# East Anglia ONE North Offshore Windfarm

## Best Practice Protocol for Minimising Disturbance to Red-Throated Diver

Applicants: East Anglia ONE North Limited  
Document Reference: ExA.AS-12.D7.V2  
SPR Reference: EA1N-DWF-ENV-REP-IBR-000535 Rev 03

Date: 25<sup>th</sup> March 2021  
Revision: Version 03  
Author: SPR / Royal HaskoningDHV

Outer Thames Estuary SPA Routeing  
- EA1N and EA2

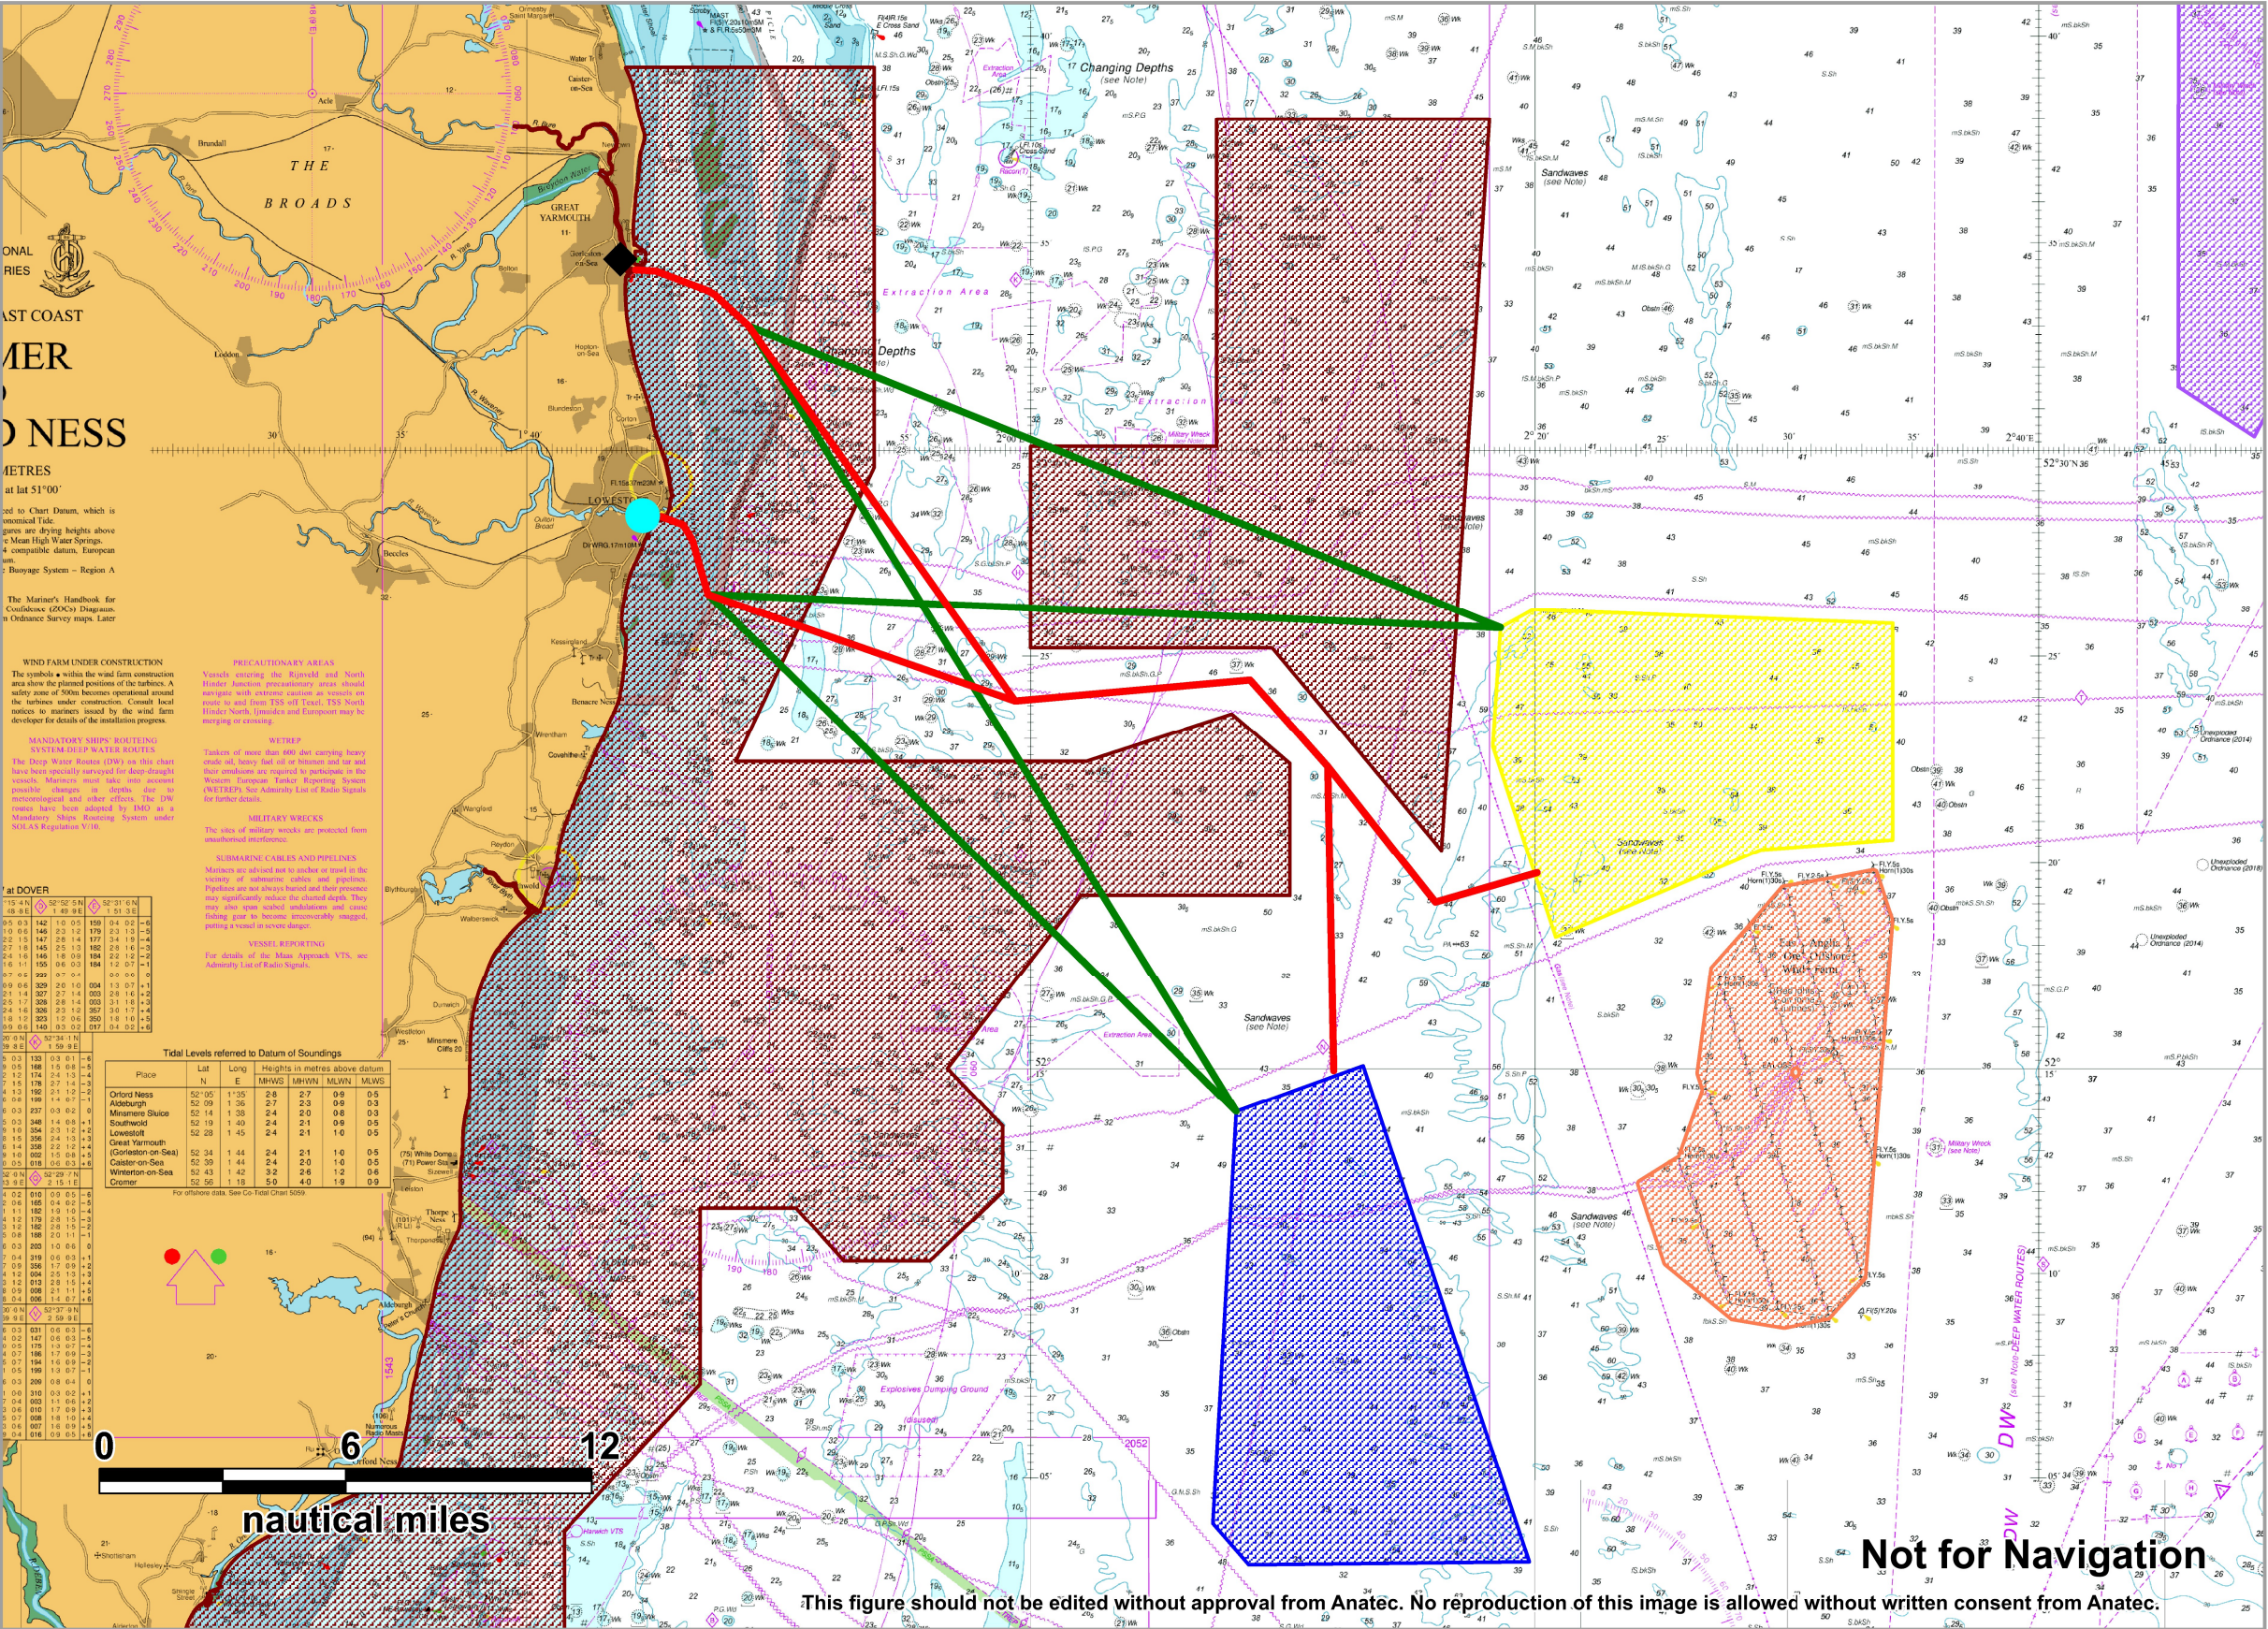
| Natural England comment                                                                                                                                                                              | Location where addressed      |
|------------------------------------------------------------------------------------------------------------------------------------------------------------------------------------------------------|-------------------------------|
| How will it be demonstrated that planned works during construction and operation phases are avoiding the sensitive periods between November and March?                                               | Addressed in <b>Section 2</b> |
| Where it is not possible to avoid works during the sensitive period how will vessel movements be managed to minimise disturbance to SPA features?                                                    | Addressed in <b>Section 2</b> |
| Provided details of particular works when vessels will be required to leave existing navigational routes through the SPA                                                                             | Addressed in <b>Section 2</b> |

3. At this stage, the construction and operation and maintenance ports have not been confirmed but are anticipated to include Great Yarmouth for construction and the existing ScottishPower Operations and Maintenance base at Lowestoft. To address the comments made by Natural England, the Applicant commission Anatec Limited to establish vessel transit routes from both ports to the windfarm site avoiding, as far as possible, the SPA with a buffer either side of the route of 2km to account for the range over which red-throated diver are known to flush from vessels in transit. The results of that exercise are shown in **Figure 1** where the anticipated 'direct routes' from each port to the windfarm site are shown in 'green' and the 'mitigation routes' in 'red'.

4. The main component of the SPA overlaps the approaches to both ports and therefore, it is not possible to avoid transiting through this part of the SPA. However, the mitigation routes have been specifically created to follow the navigation approaches to both ports, and thus limit the impact of the Projects' vessel movements to areas of existing navigation routes associated with the ports, where the densities of red-throated diver are typically relatively low.

5. Once beyond the main components of the SPA, vessel traffic from either port has been routed through the gap between the main component and northern component of the SPA. This gap generally allows for a 4km width, with the exception at its narrowest where the gap is orientated northwest -southeast for a short section. At the point the gap is reduced to between 2.75 and 3.30 km, preventing a full 4km width. It should also be noted that alternative mitigation routes could also be used, but avoidance of the SPA beyond the Approaches to the ports would be maintained.

7. The Applicant commits to implementing the measures outlined above and provided in **Figure 1** by all project vessels throughout the construction and operation of the Project through the core winter period of 1<sup>st</sup> November to 1<sup>st</sup> March inclusive.
